City of Bellevue
Development Services Department
Land Use Staff Report

Proposal Name:	**Tyee Middle School**
Proposal Address:	13630 SE Allen Road
Proposal Description:	Application for a Critical Areas Land Use Permit to replace the existing dirt soccer field with an expanded synthetic turf field. Expansion of the field requires modification of the western edge of the steep slope and stream buffers via a critical areas study.
File Number:	11-13630-LO
Applicant:	Bellevue School District, #405
Decisions Included:	Critical Areas Land Use Permit (Process II. 20.30P)
Planner:	Antoinette Pratt, Senior Planner
State Environmental Policy Act Threshold Determination:	**Determination of Non-Significance Issued November 29, 2011, by Bellevue School District #405.**
Director's Decision:	**Approval with Conditions** **Michael A. Brennan, Director** Development Services Department By: Carol V Helland Carol V. Helland, Land Use Director

PLANTING PLAN

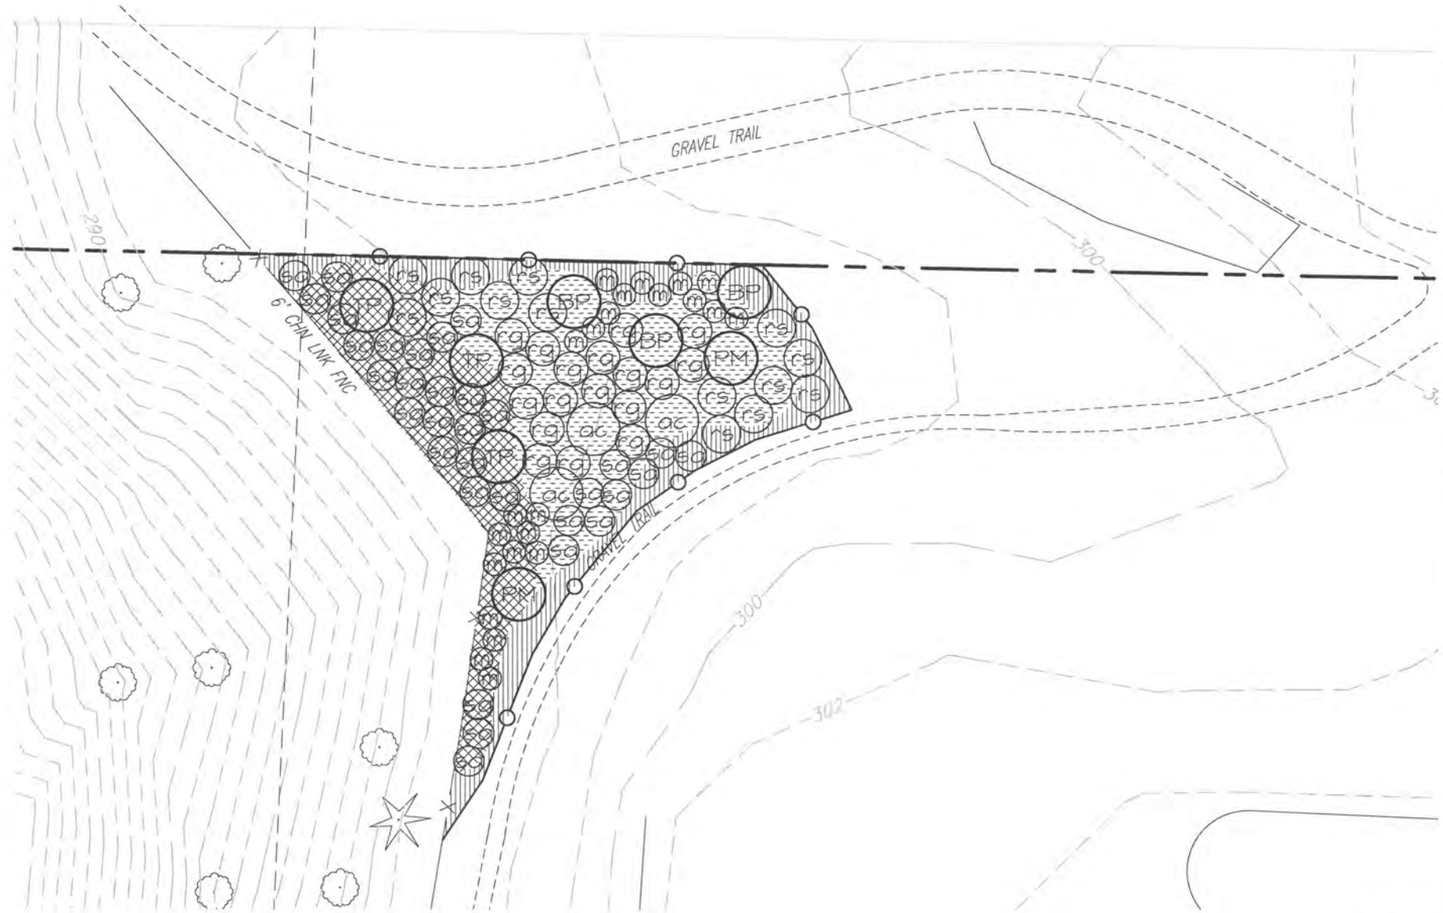
Finding: The Watershed Company has proposed a mitigation plan for the synthetic field expansion. Staff has reviewed and approved the plantings noted on Sheet W3 of 5. Upon installation, staff will review for compliance with submitted plans.
